CITY OF ALBUQUERQUE

RE: **Lot 5 Block 5 S.A.D. 227 Unit 5**
8008 Victoria Dr. NW
Grading and Drainage Plan
Engineers Stamp Date 1/13/2021 (E10D094)

DRAINAGE AND TRANSPORTATION INFORMATION SHEET (REV 6/2018)

ENGINEER'S SEAL DAVID SOULE REGISTERED PROFESSIONAL ENGINEER 14522 1/13/21 DAVID SOULE P.E. #14522	LOT 5 BLK 5 UN 5 VC 8008 VICTORIA DRIVE GRADING AND DRAINAGE PLAN 	DRAWN BY DEM DATE 1-12-21 LOT 5 BLK 5 UN 5 VC.DWG SHEET # C1 JOB #
--	--	--

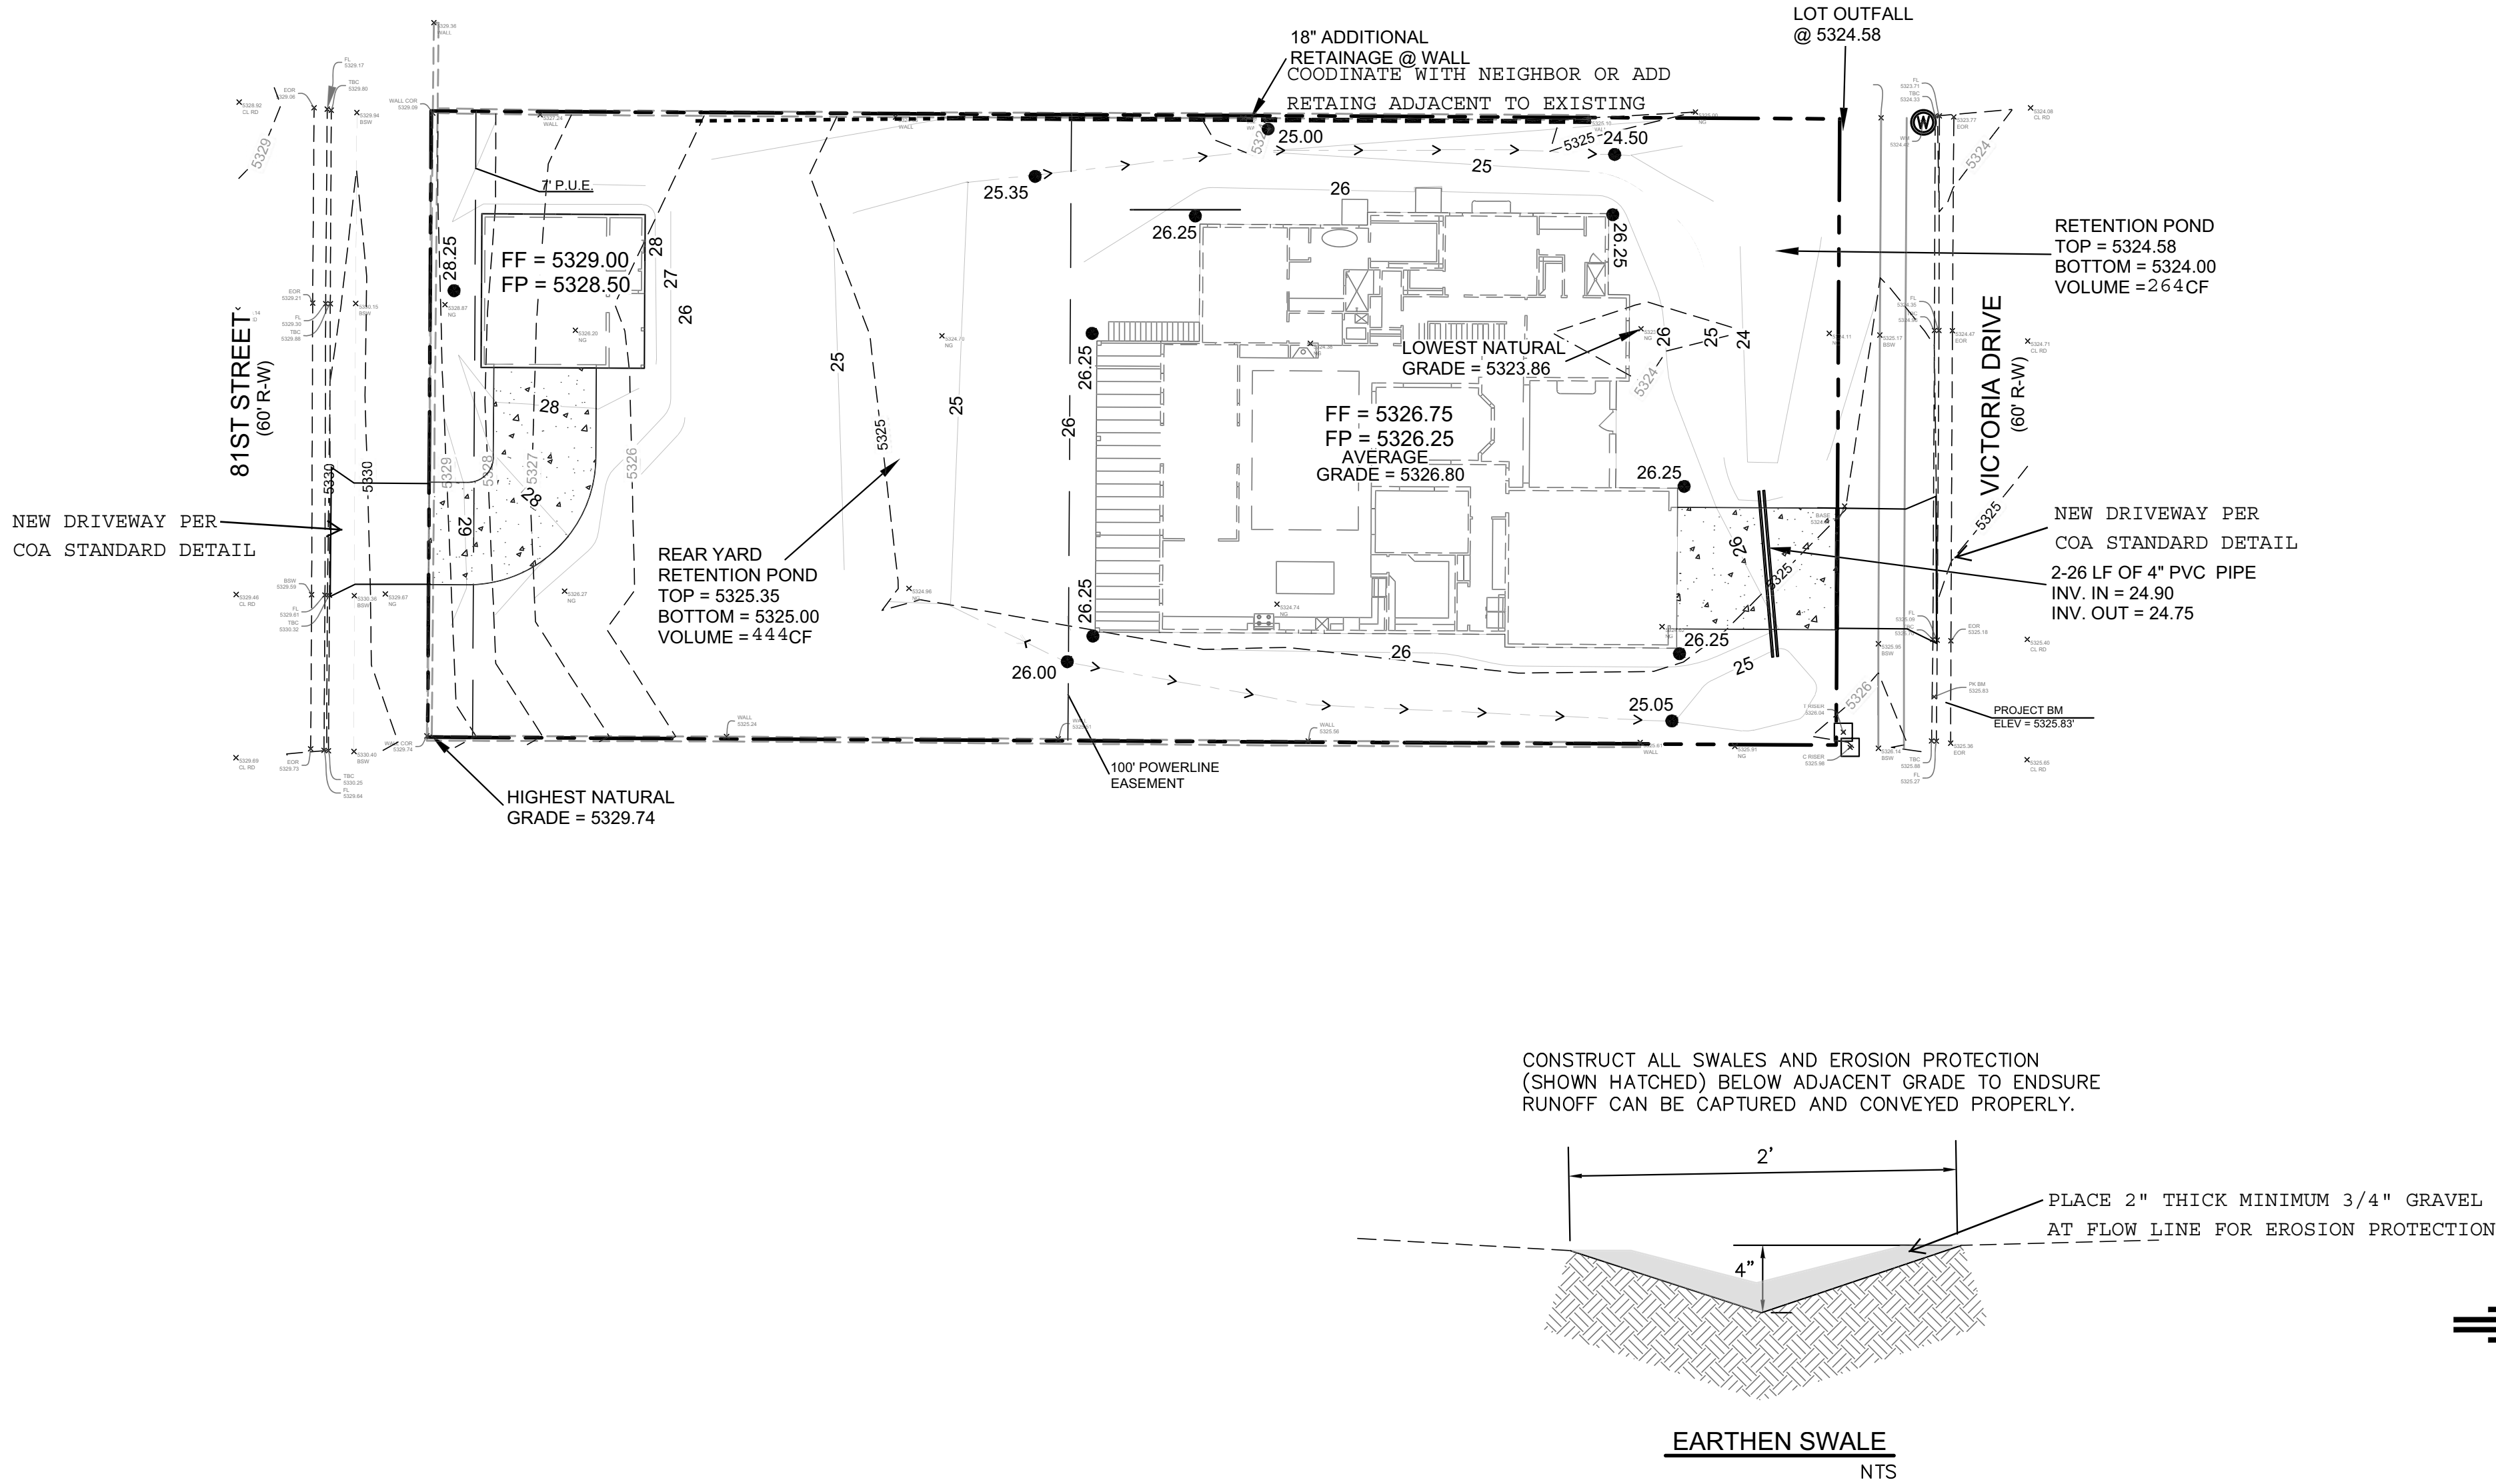
Based upon the information provided in your submittal received 1/13/2021, this plan is approved for Grading Permit. Please inform the builder/owner to attach a copy of this approved plan and letter into the construction sets in the permitting process prior to sign-off by Hydrology.

Reiterate to the Owner/Contractor that a separate permit for any garden/retaining wall must be obtained, with the approved G&D plan. Advise the owner contractor not to use dirt as a ramp to climb the curb, use lumber or crusher fines for this purpose. Also, let the owner/contractor know that if a pool is to be added in the future the G&D plan will need to be modified showing the location of the pool and the land treatment differences.

Prior to Building Permit approval, a **Pad Certification** will be required. Inform the contractor/owner not to pile dirt in the street as a ramp to climb the curb. If dirt is found in the street the pad cert. will be denied.

Prior to **Certificate of Occupancy release**, Engineer Certification per the DPM checklist of this plan will be required.
